Gilgai and reactive soil geohazards in the City of Melton

Including the Planning Application for a
Place of Worship at 171-197 Harkness Rd,
Harkness

Prepared by: Associate Professor Peter Dahlhaus, Principal Research Fellow
Prepared for: Melton City Council

- 9) I have been asked to provide a report addressing the following (refer Harwood Andrews letter reference 2KXM:5AKT 21804177 dated 19 November 2018, a copy of which is attached in Appendix A).
1. Provide a peer review of the Dahlhaus Report.
 2. Provide a preliminary opinion on:

Figure 12. Proposed site classification for the Harkness area (1986).

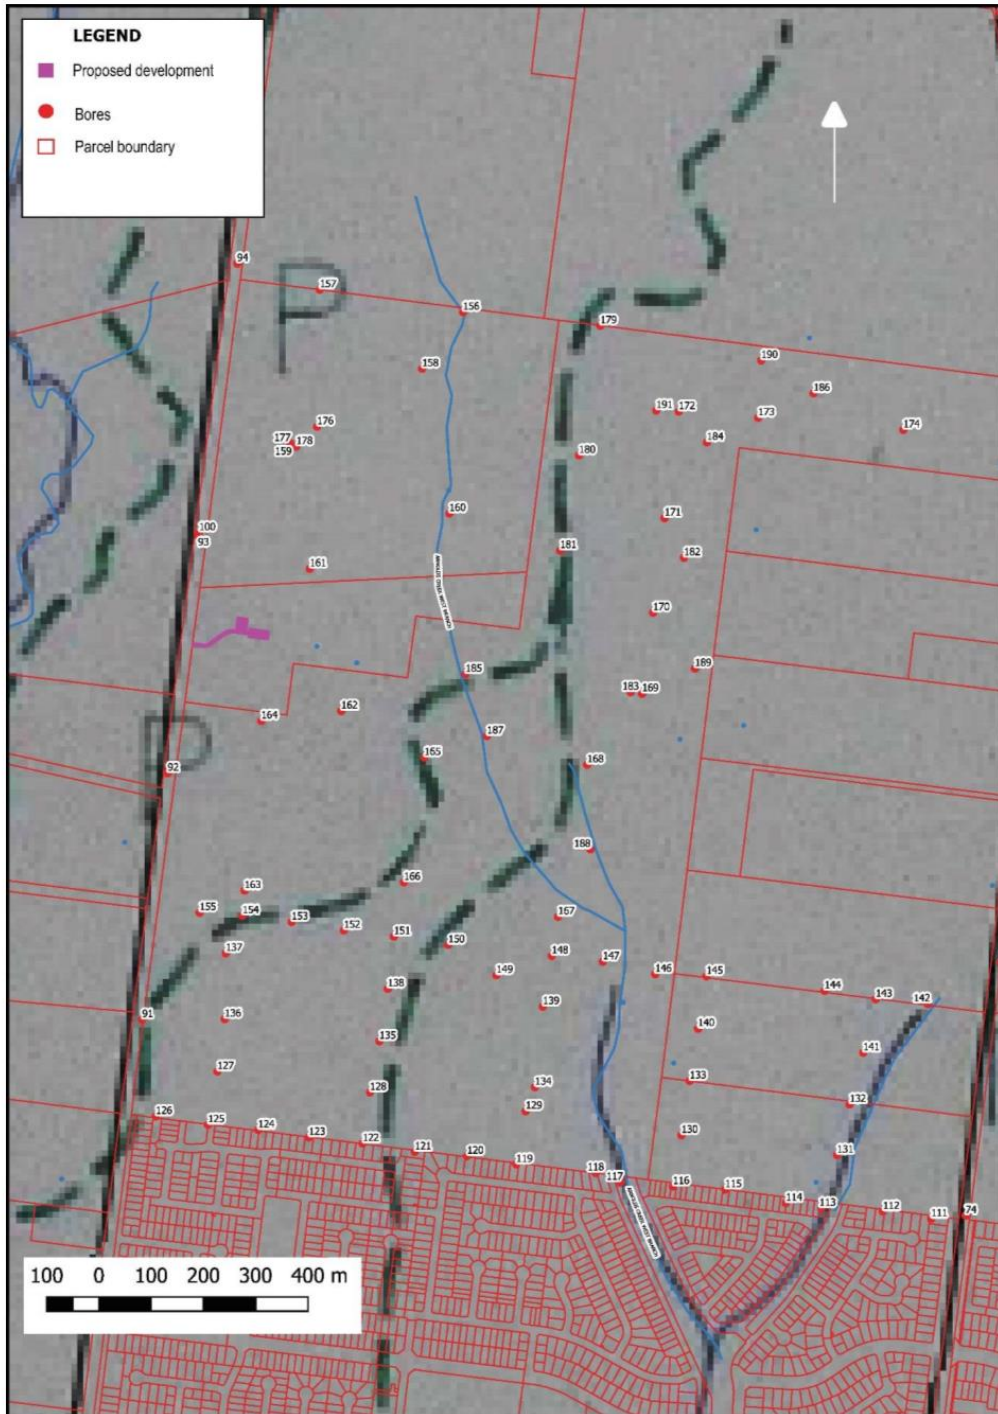
Unsurprisingly, given the limitations and constraints of the ground conditions, the area was classified a Class P (Problem) in AS2970-1986 (Figure 12). The original standard is now superseded by AS2870-2011, which defines:

Hence the Class P remains the current classification given the site conditions.

The proposed development lies in the polygon designated as Class P (Problem soil).

Figure 13. Enlarged view of the modelled soil thickness map (1986), with the bore locations. The proposed development is underlain by soils modelled as around four metres thick.

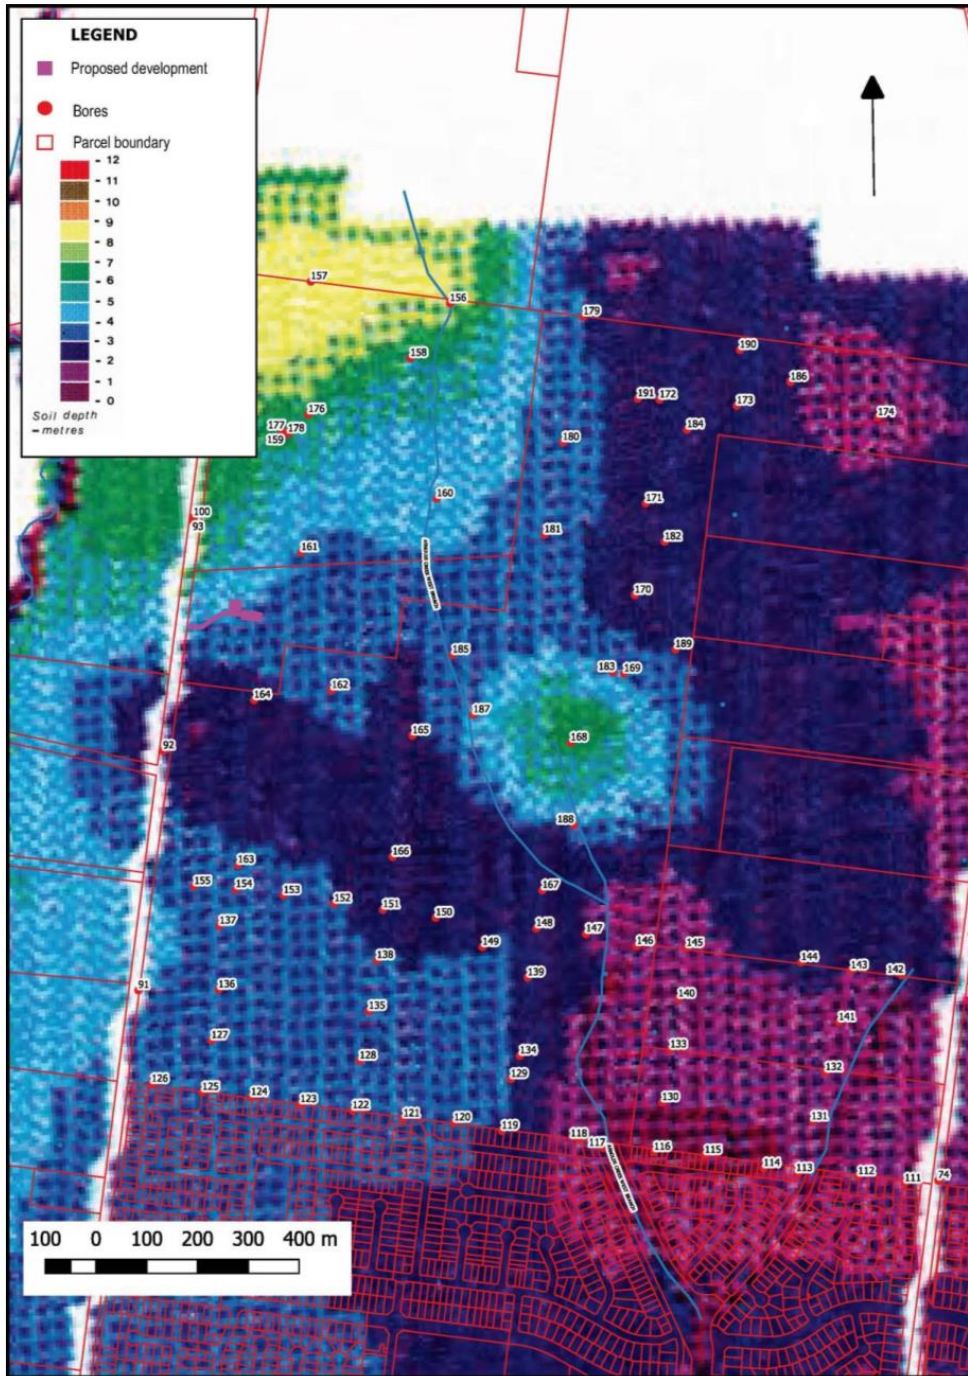
The closest bores to the site are designated as Djerriwarrh 93, 100, 161 and 164 (Figure 13). Bores 93 and 100, in the Harkness Road reserve north west of the site, show >4.2 metres and 7.5 metres of moist, very stiff, mottled yellow-brown and grey sandy silty clay. Bores 161 and 164, to the north east and south east respectively, show 3.2 metres of moist, stiff, fissured, mottled yellow brown and grey, silty clay overlying extremely weathered basalt. In both cases, the clay is fissured to the full depth of the bore, with soil shear (slickensides) evident. From these bores it is interpolated that the thickness of clay under the site would be around four metres (Figure 13). Four metres of highly to extremely reactive clay creates considerable seasonal movement (shrink-swell) and poses a challenge to the engineering and design of the development.

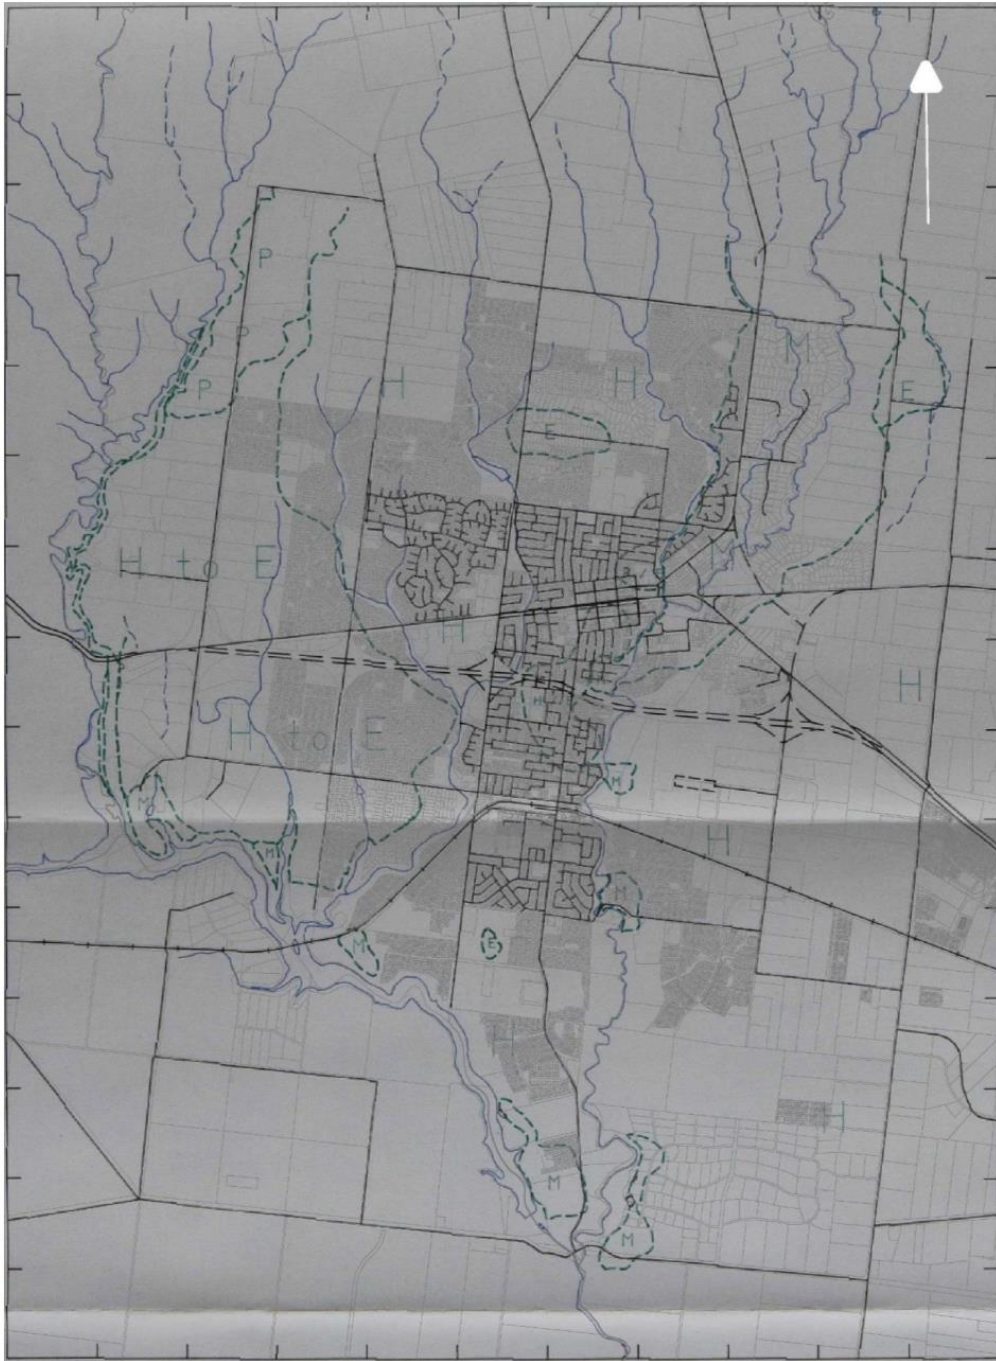
Figure 14. Some of the more obvious geohazards at the proposed development site as seen in aerial imagery. (source Melton City Council. Imagery captured January 16, 2018)

The soil collapse features are obvious on the east of the Applicant's site (Figure 14) and subtle gilgai depressions are noted on the western side, confirming² that the likelihood of geohazards at the site is Certain (Table 2). The consequence of the geohazards will depend entirely on the engineered solution. This would require a detailed geotechnical investigation to inform the potential engineered solutions and landscape design elements. The most challenging of these is the enduring management of soil moisture, which is the trigger for the geohazard processes. Hence, the wastewater disposal, runoff and storm water management, vegetation species selection and siting, garden irrigation, and the extents of the impervious surfaces are the most critical design considerations. However, even if the development could be engineered and designed to reduce the consequences of the geohazards to Moderate or Minor (Table 3), the risk remains High to Moderate (Table 4).

² A site inspection on 30/8/2018 also confirmed the presence of the geohazards seen in Figure 14
